PLANT NAME: Oconee Units 1-2-3  
*Rec'd for disd 7/7/77*  
RJL 7/12/77

Response to request for additional information concerning Turbine Building flooding w/ attached drawings.....

RESPONSE TO REQUEST FOR ADDITIONAL INFORMATION  
CONCERNING TURBINE BUILDING FLOODING

TURBINE BUILDING FLOOD DRAIN  
GENERAL ARRANGEMENT  
EQUIPMENT AND ACCESS LOCATIONS  
FIGURE NO. 2

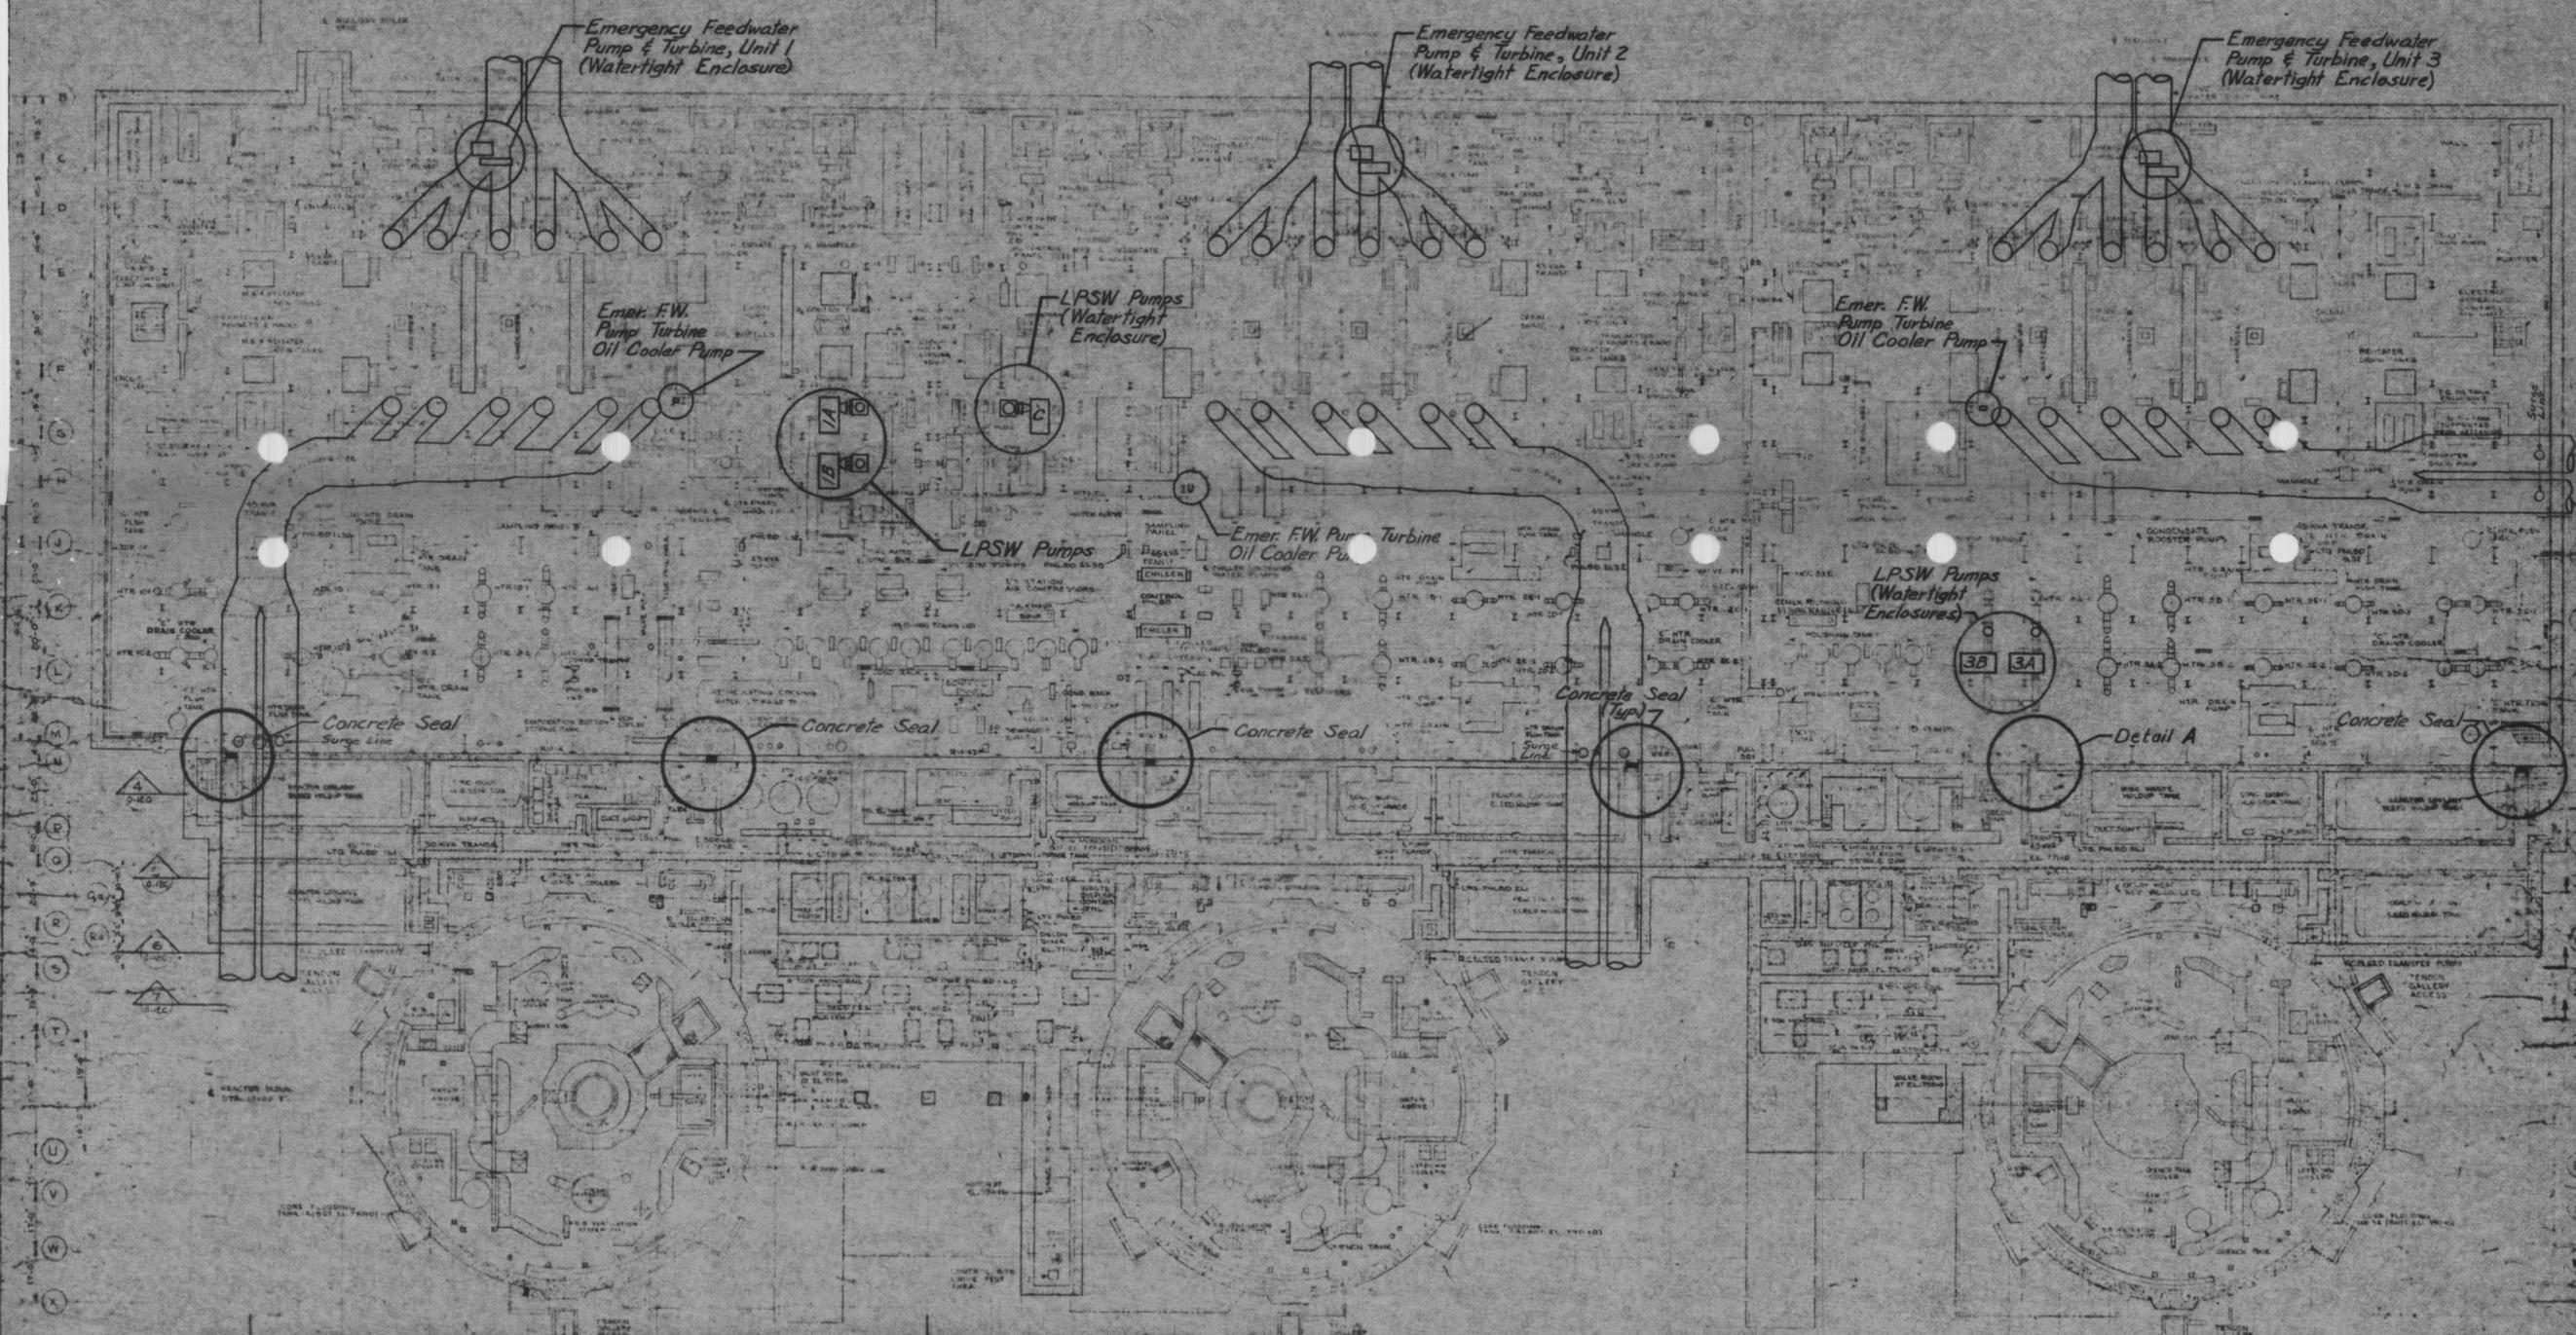
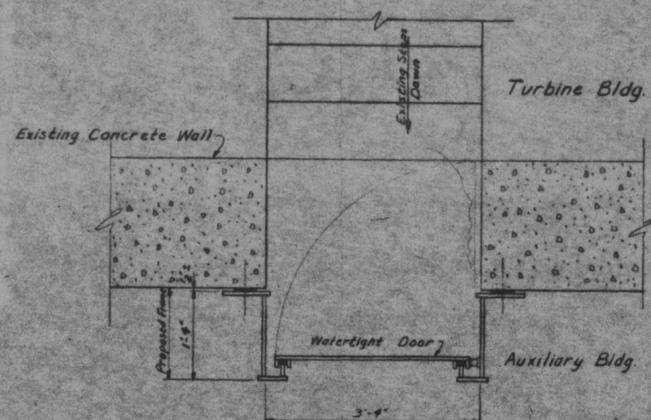
With the aid of appropriate plan and elevation views locate the components.

Identify and locate on drawings all flood water pathways that formerly existed between the turbine building and the areas housing essential equipment.

The equipment locations, both in plan and elevation views, are indicated on the attached Figure 2.

Figure 2 locates and identifies the major Turbine/Auxiliary Building wall openings which consist of six access doorways at the basement level. Minor pipe sleeve penetrations also exist below the maximum flood water elevation.

TURBINE BUILDING FLOOD DRAIN  
 CCW CROSSOVER  
 LPSW CONNECTIONS  
 FIGURE NO. 3

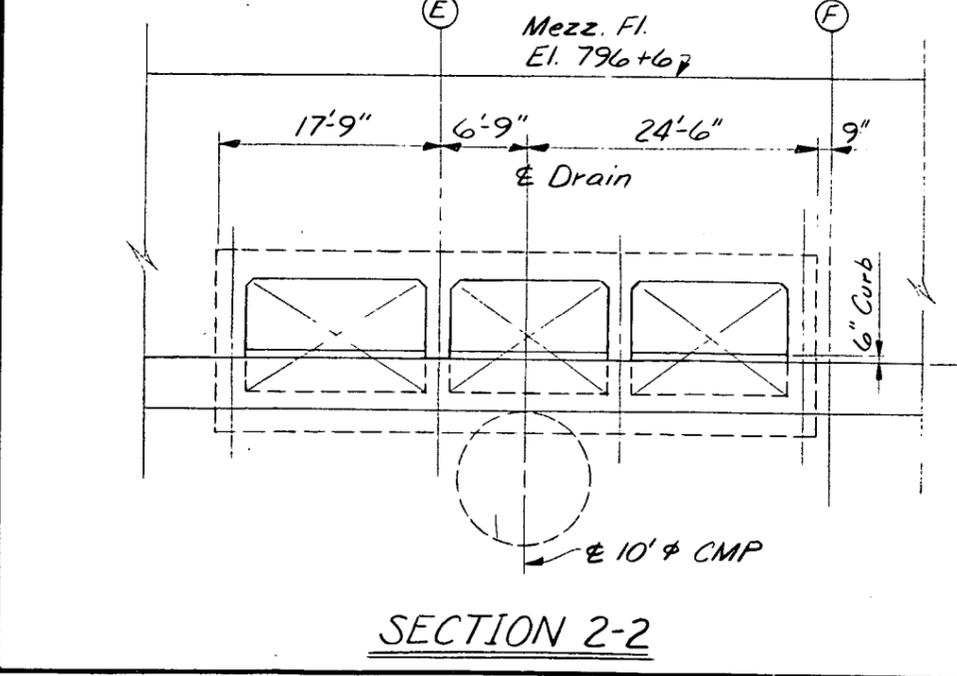
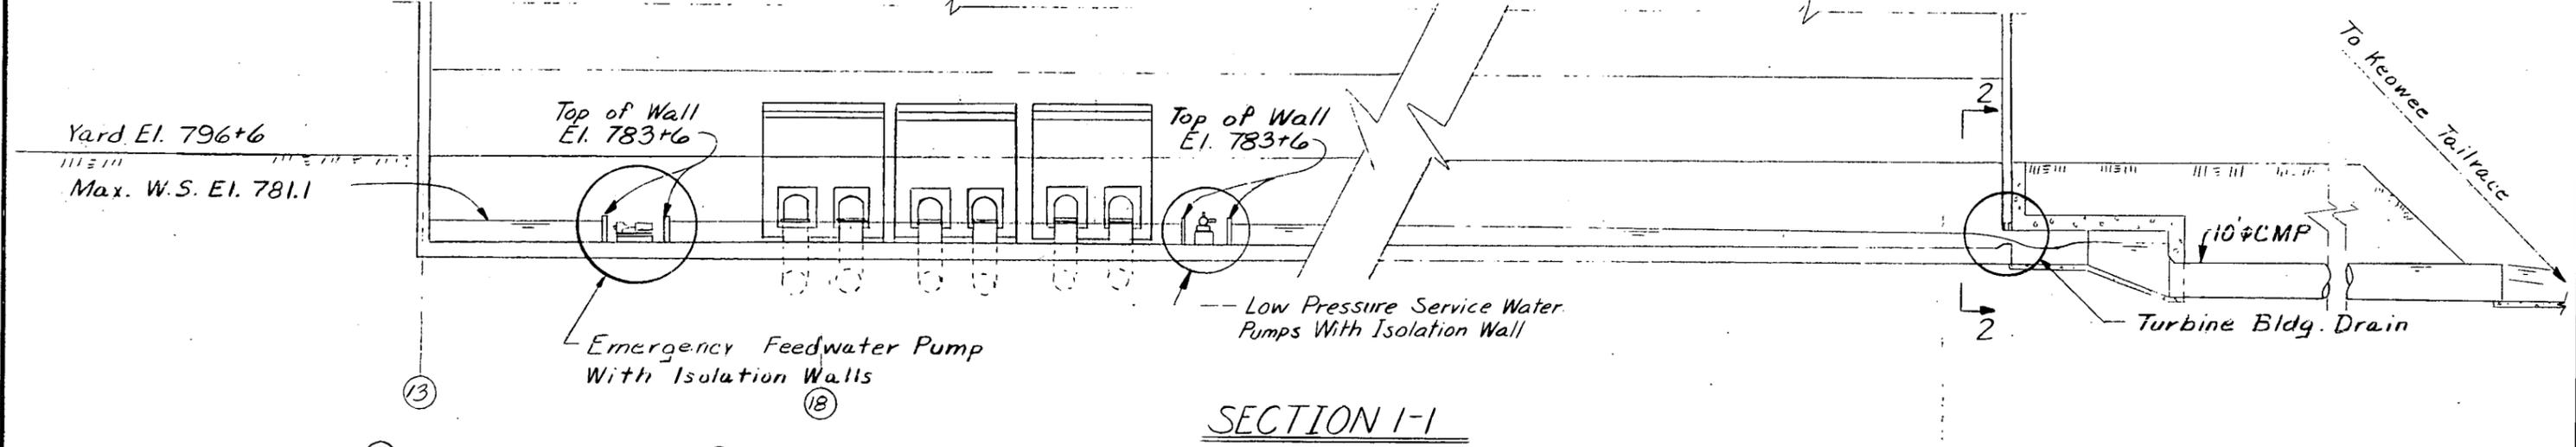
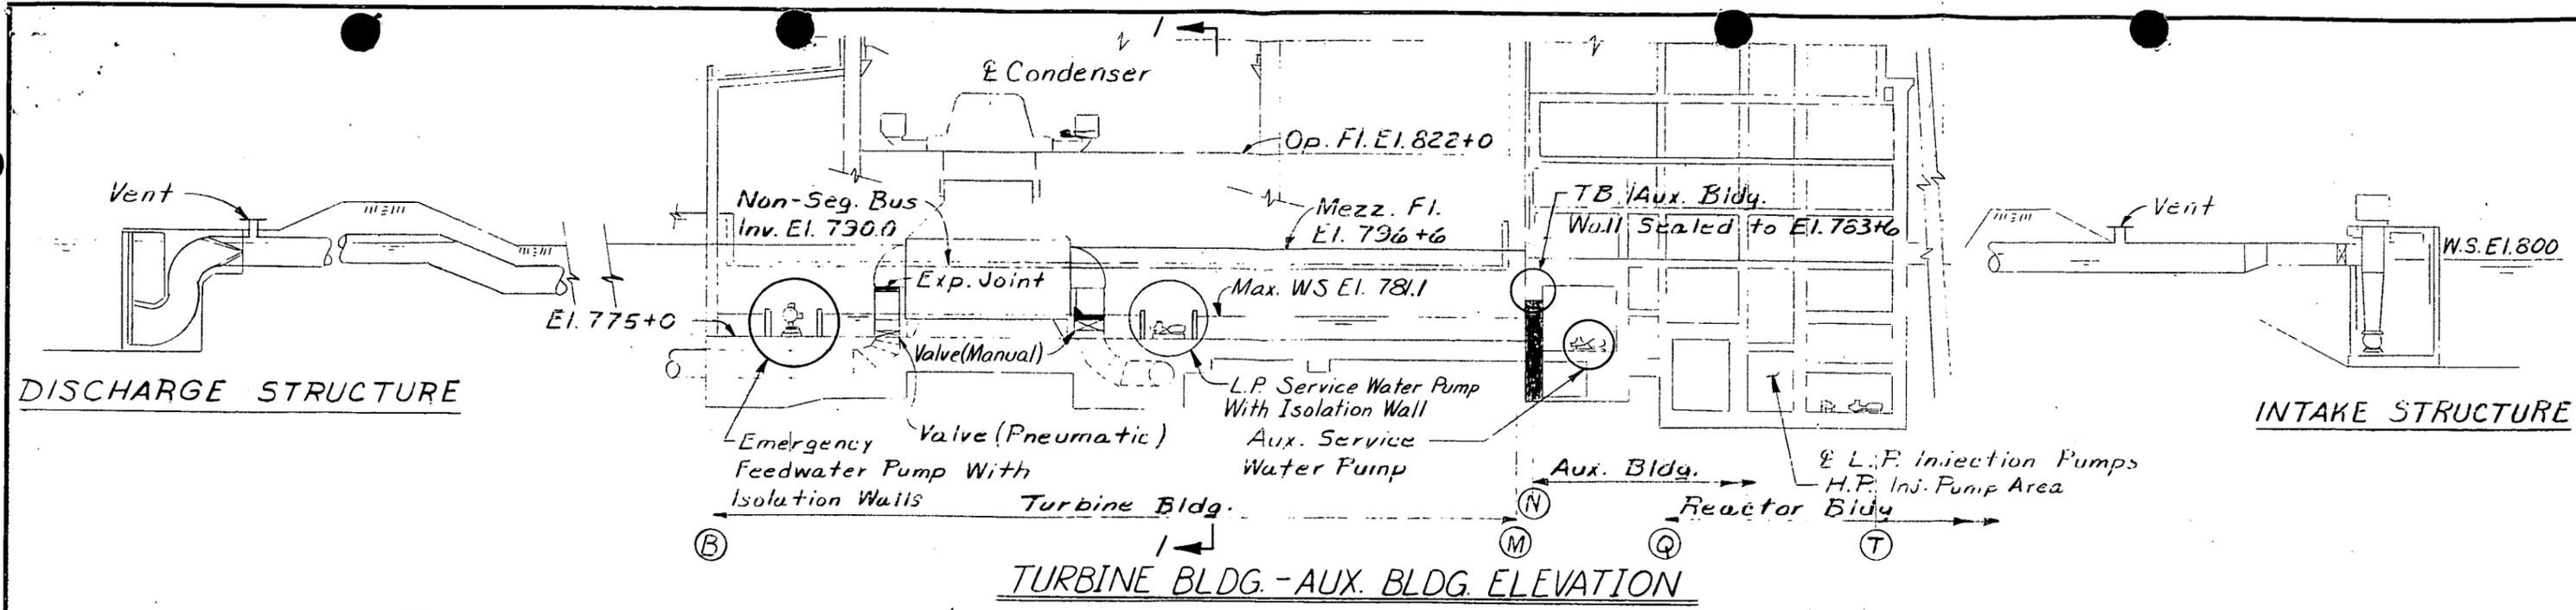
With the aid of a diagram make layout of the Condenser Cooling Water Systems (CCW) for Units 1 and 2, show the take off points on the crossover line between Units 1 and 2 for the High Pressure Service Water and Low Pressure Service Water Systems. In addition, since these systems are essential service water systems provide a discussion which demonstrates that the functioning of these systems are immune to any single failure in the Condenser Cooling Water System, crossover line, or the condenser box non-seismic butterfly valves (termination point of the seismic Category 1 portion of the CCW system).

Figure 3 shows the CCW System for Units 1, 2, and 3, the cross-over line and the branch connections for the LPSWP's. No credit is taken in this analysis for the High Pressure Service Water Pumps and thus the connections for these pumps are not shown.

Various conservative net positive suction head calculations have been performed which indicate that any single failure to the CCW System piping, the condenser waterbox, crossover line, or the condenser waterbox non-seismic butterfly valves will not jeopardize the proper operation of the LPSWP's. The calculations were performed for both the minimum and maximum operating lake levels assuming breaks at elevation 775 in either the CCW pipe or the crossover line. The calculations proved that there was no deficiency in NPSH due to the effect of excess water flowing through the crossover line to the break location.

Each of the three crossover valves will be backfitted with reach rods. Thus, if a break occurs in the Unit 1 CCW pipe, the valves at the Unit 1 intake structure along with the Unit 1 crossover valve will be closed to isolate the leak. Unit 2 and 3 CCW Systems will continue to supply water to the LPSWP's. A break in any one of the units CCW System would be similarly isolated. The available NPSH will increase following this operation due to the lower flow through the crossover line.

TURBINE BUILDING FLOOD DRAIN  
 CONCEPTUAL ARRANGEMENT  
 FIGURE NO. 1

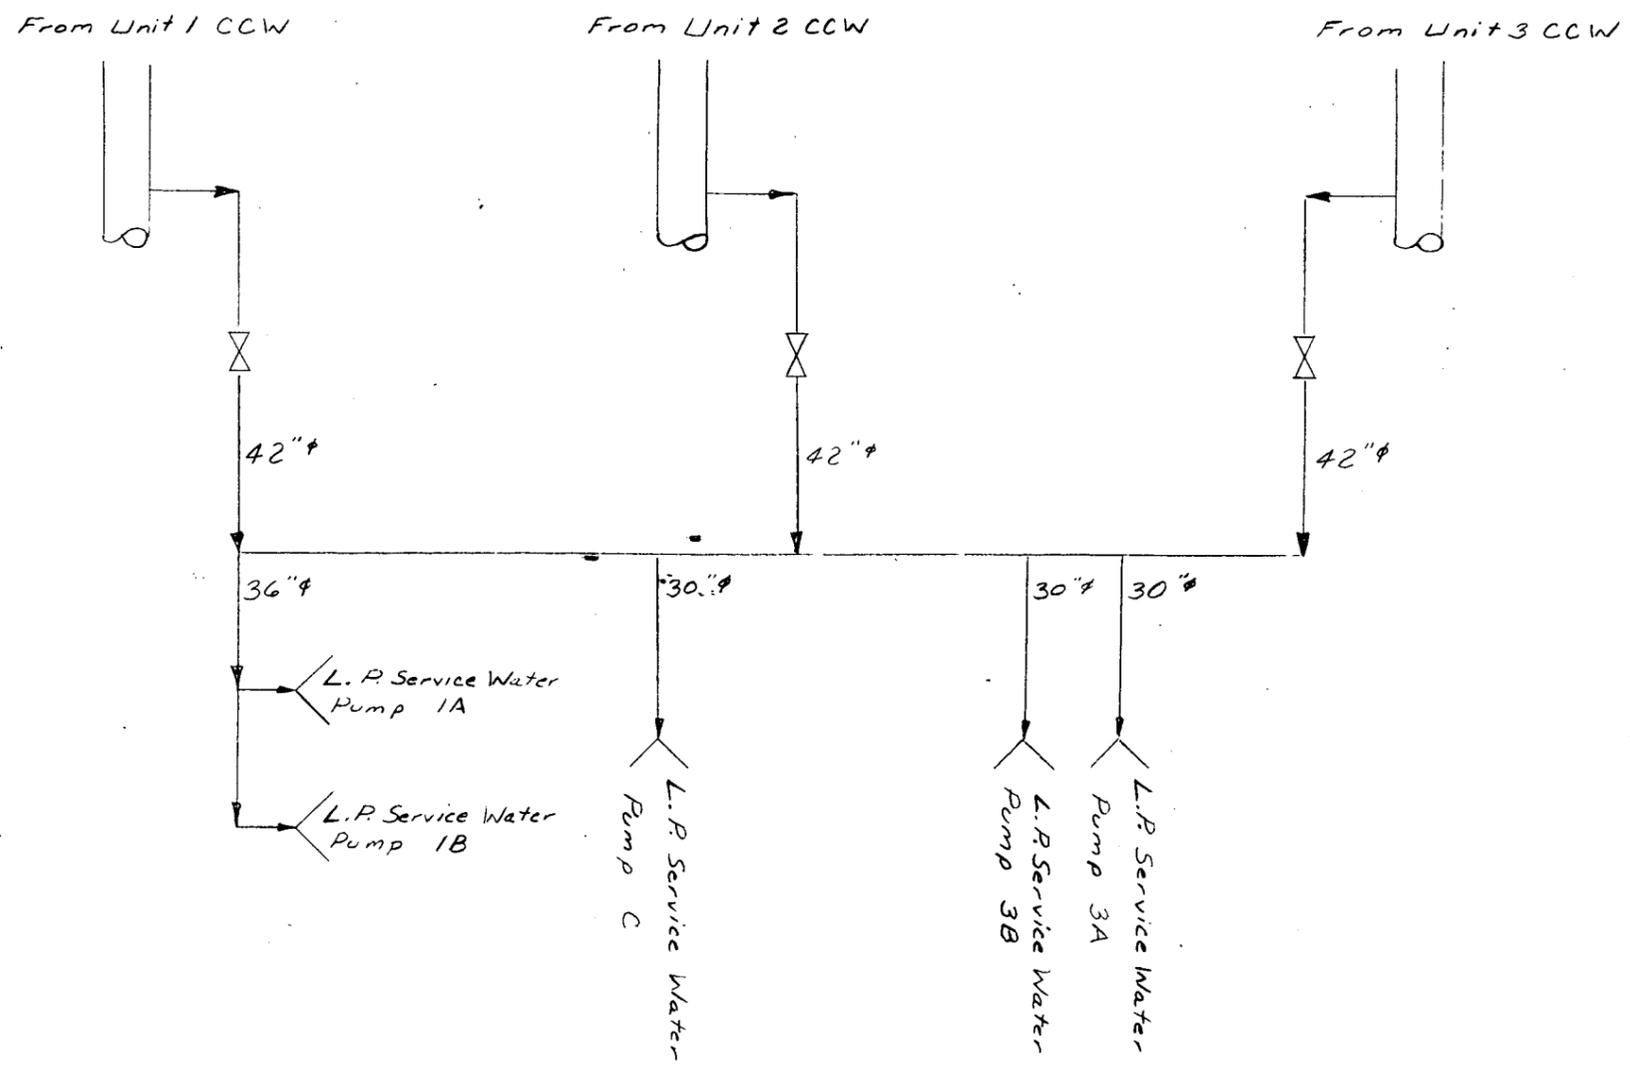
With the aid of drawings illustrate and describe the protective measures taken to lower the maximum flood water level or otherwise protect the equipment.

Figure 1 illustrates the combination of protective measures which will be taken to minimize the Turbine Building flood water level and protect critical equipment. The attachment to Mr. W. O. Parker, Jr.'s letter of April 21, 1977, describes the operation of the Turbine Building drain during the design basis flood.
